**PLANNING  
COMMISSION  
EXHIBIT # 16A**

Re: The "Preserve"; File No. 3029/04-207

CONVENTIONAL SUBDIVISION - W/ GOLF COURSE

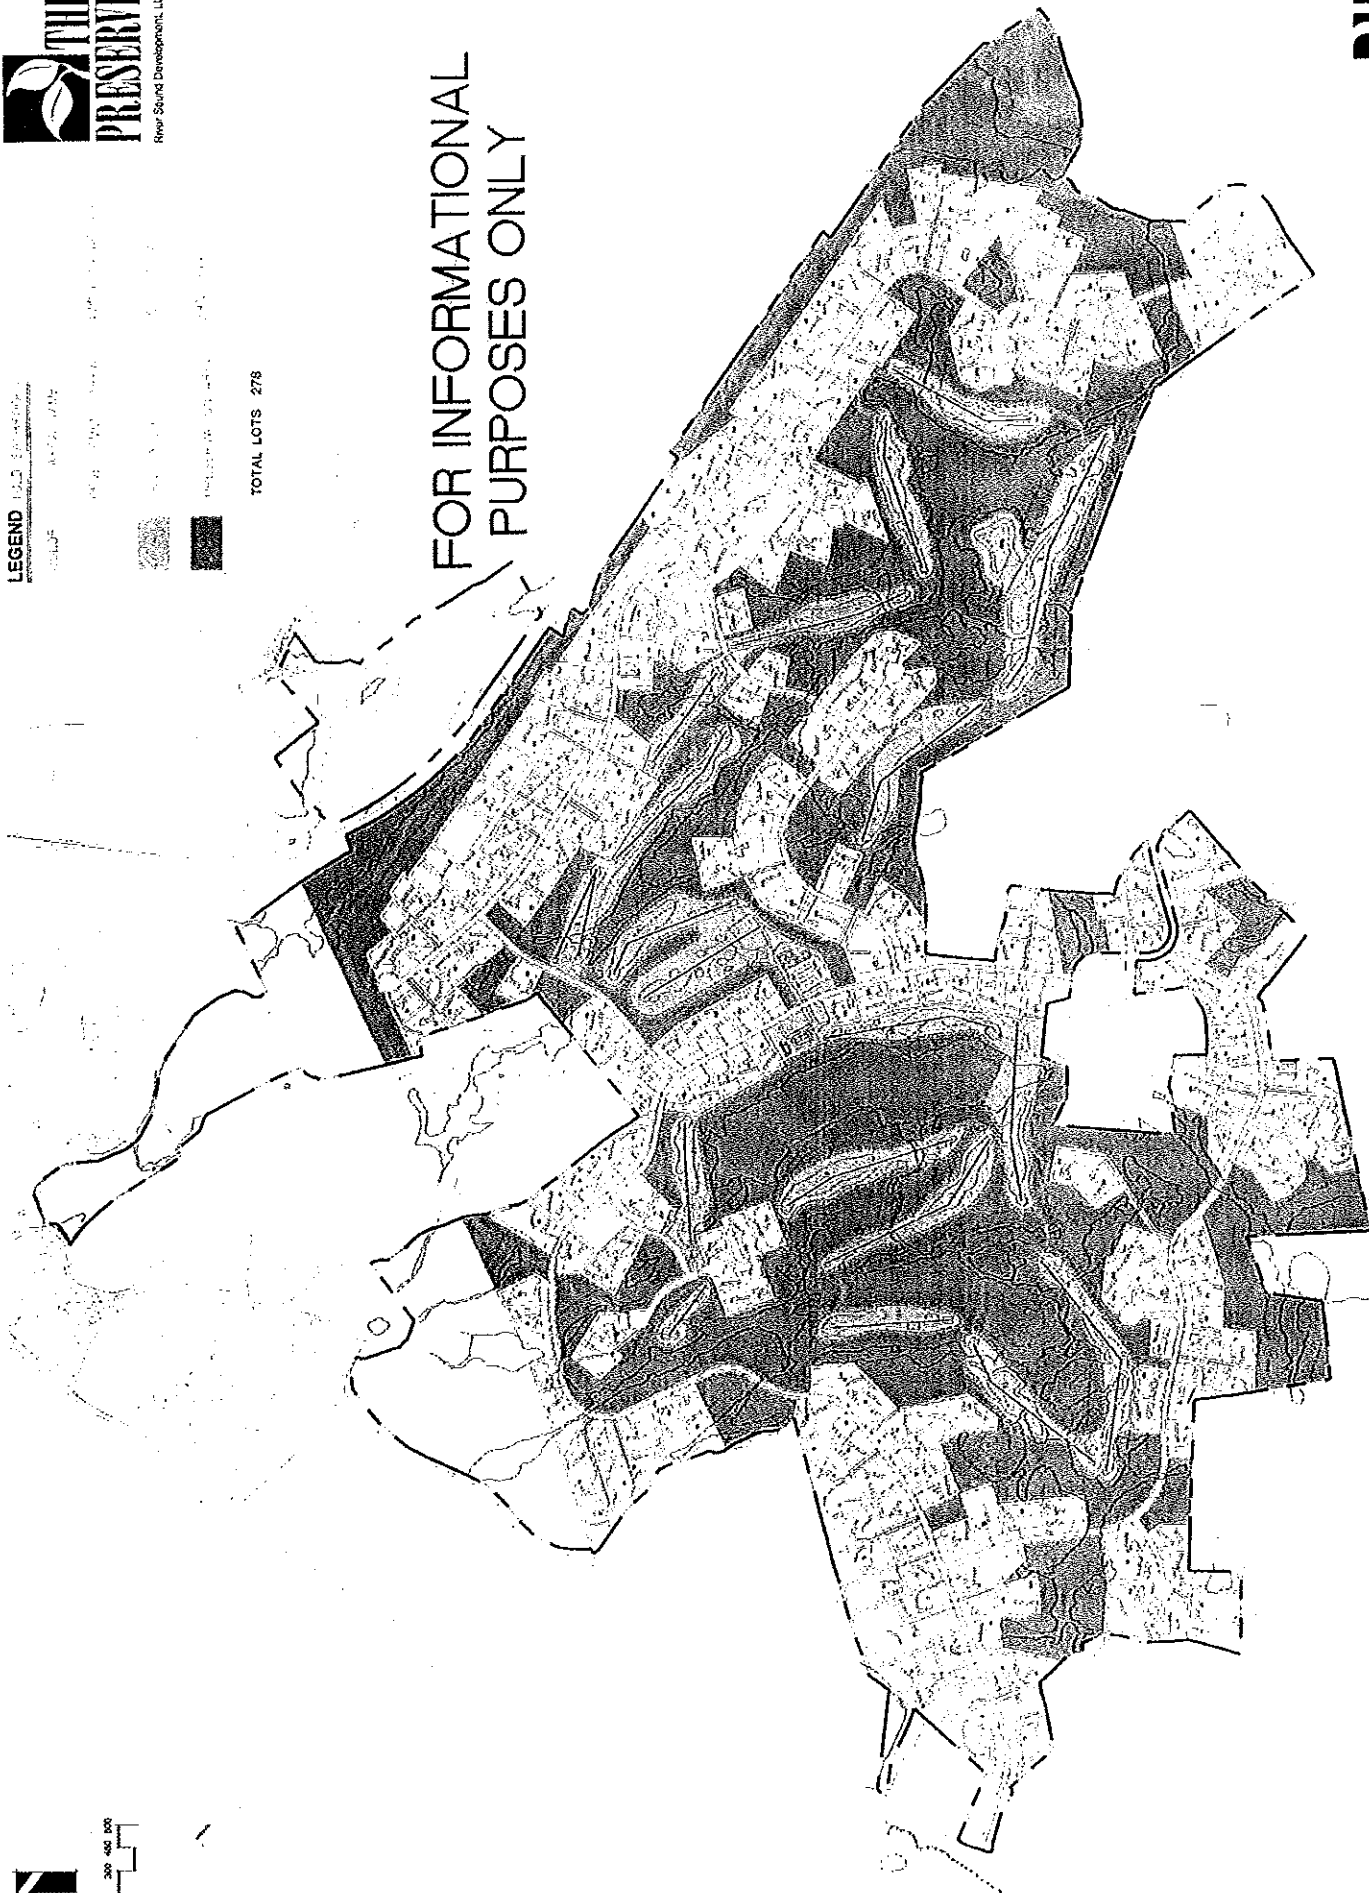
Instead of providing the information requested by the Commission, River Sound has provided a plan sheet showing how a different and clearly unworkable golf course would "fit" within a different conventional subdivision. (See "Conventional Subdivision – w/ Golf Course" sheet; photo-reduced copy enclosed). River Sound's unwillingness to provide the requested information frustrates the purpose of the Open Space Subdivision regulation – to allow the Commission to make an "apples-to-apples" comparison of the conventional and open space plans.

River Sound's attempt to substitute in a new conceptual plan also highlights the extent to which an applicant can reverse engineer the conceptual standard plan to suit its needs when it is not constrained by either (1) the requirement that the plan contain a "reasonable subdivision" plan (§ 56.4) or (2) the environmental planning standards endorsed and employed by its own environmental consultant, Dr. Klemens. It is clear that the modified "Conventional Subdivision – w/ Golf Course" plan would not be approved with, among other things, golf course holes 12 and 13 traversing one of the most productive and environmentally sensitive areas of the site- as identified by Dr. Klemens and all of the other environmental consultants that testified. Further, River Sound's attempt to interject a new plan now deprives the public and Commission staff the proper opportunity and information to analyze the revised layout, lots, and golf course for compliance the regulatory standards including road grades and MABL as required in § 56.3.1.

Applying the golf course lot proposed in the River Sound's open space subdivision plan to River Sound's conceptual standard plan reveals a conventional layout plan with a yield that is approximately 100 units less than the 293 units claimed by River Sound and which still contains all of the environmental shortcomings of the proposed golf course. The Town of Essex again respectfully urges the Commission to reject River Sound's poorly conceived plan for the above stated reason as well as the other reasons and inter-municipal impacts previously presented.
